SB & Labelling 19 – Information Sheet

CER Checklist item: SB & Labelling 19

Are circuits that are backed up when the grid is not available appropriately labelled to indicate their function?

Figure 1: An option of labelling alternative supply circuit within the switchboard.

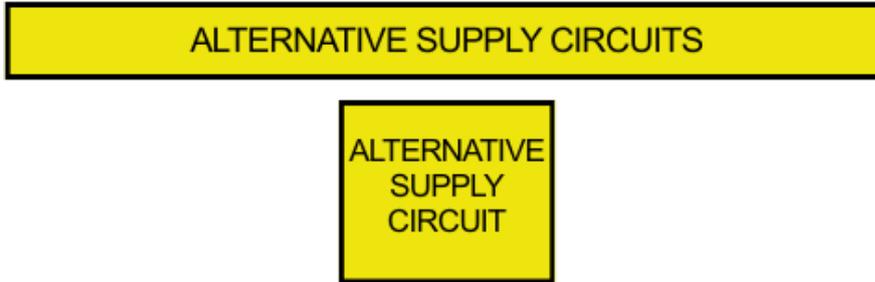
Final subcircuits supplied by an alternative supply from an IES shall be located in a dedicated alternative supply switchboard.

Exception: Where not reasonably practicable, the alternative supply final subcircuits may be located in a switchboard with other circuits not supplied by the alternative supply. The alternative supply final subcircuits shall be grouped.
